**ALERT SERVICE BULLETIN**  
**Bell Helicopter** **TEXTRON**

NO. 427-06-14

**MODEL AFFECTED:** 427

**SUBJECT:** BUS BAR, REPLACEMENT OF

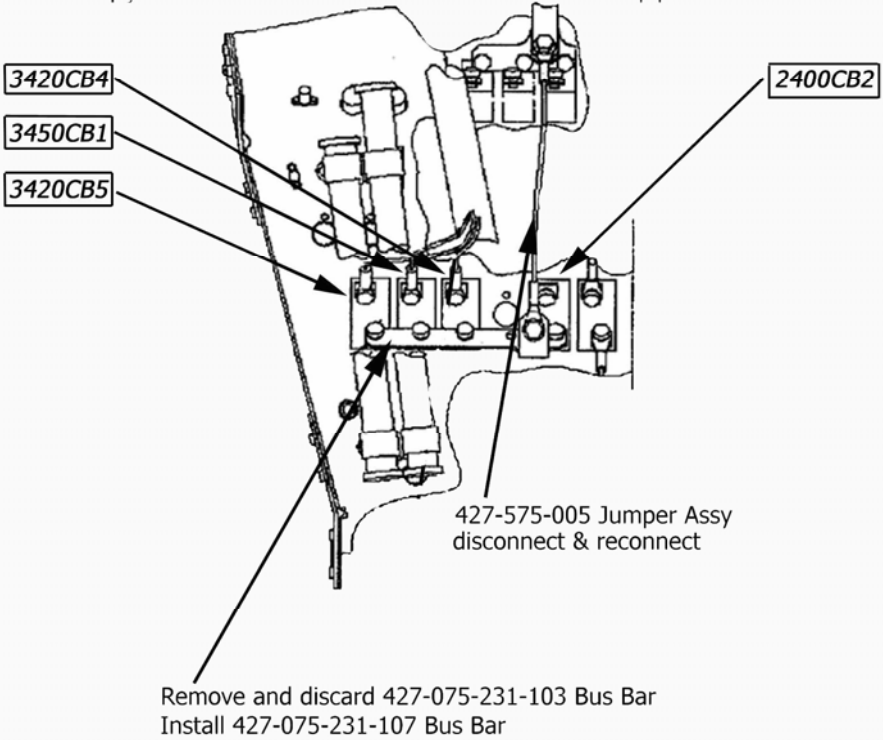
We have received a report indicating there is the possibility of interference between the bus bar of the flight instruments switches and the Interconnect Bus Switch located in the overhead circuit breaker panel.

This bulletin replaces the bus bars with a newly created bus bar that allows for more clearance.

1. Disconnect rotorcraft's battery. Ensure no external power is applied either.
2. Gain access to the cockpit's overhead circuit breaker panel by loosening the eight (8) flat head fasteners holding it in place. Carefully lower the subject panel until it rests at an almost vertical position.
3. Remove the 427-706-002 jumper assembly. (see figure 1)
4. Remove and discard the 427-706-002-117 Bus Bar and install the replacement 427-075-231-107 Bus Bar using existing hardware.(see figure 1)
5. Re-install the 427-706-002 jumper assembly using the existing hardware. (see figure 1)
6. Annotate the helicopters technical records to reflect compliance with this bulletin.

<u>Part Number</u>	<u>Nomenclature</u>	<u>Quantity</u>
427-075-231-107	Bus Bar	1 per A/C

Figure 2 -Flight Instrument and IIDS cooling configuration

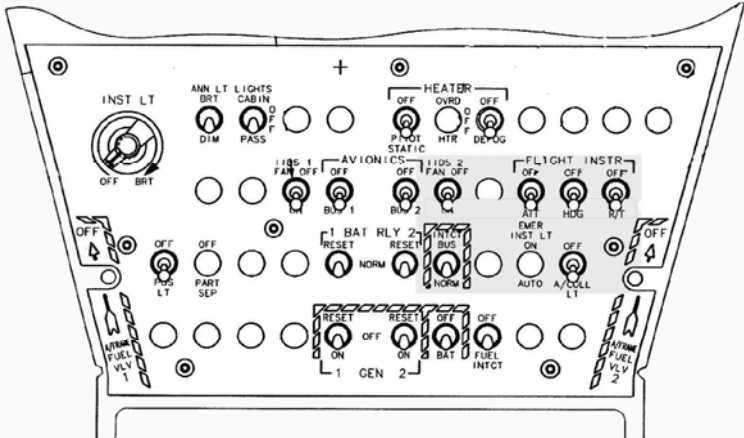
1. Disconnect rotorcraft's battery. Ensure no external power is applied either.
2. Gain access to the cockpit's overhead circuit breaker panel by loosening the eight (8) flat head fasteners holding it in place. Carefully lower the subject panel until it rests at an almost vertical position.
3. Remove the 427-575-005 jumper assembly. (see figure 2)
4. Remove and discard the 427-075-231-103 Bus Bar and install the replacement 427-075-231-107 Bus Bar using existing hardware.(see figure 2)
5. Re-install the 427-575-005 jumper assembly using the existing hardware. (see figure 2)
6. Annotate the helicopters technical records to reflect compliance with this bulletin.
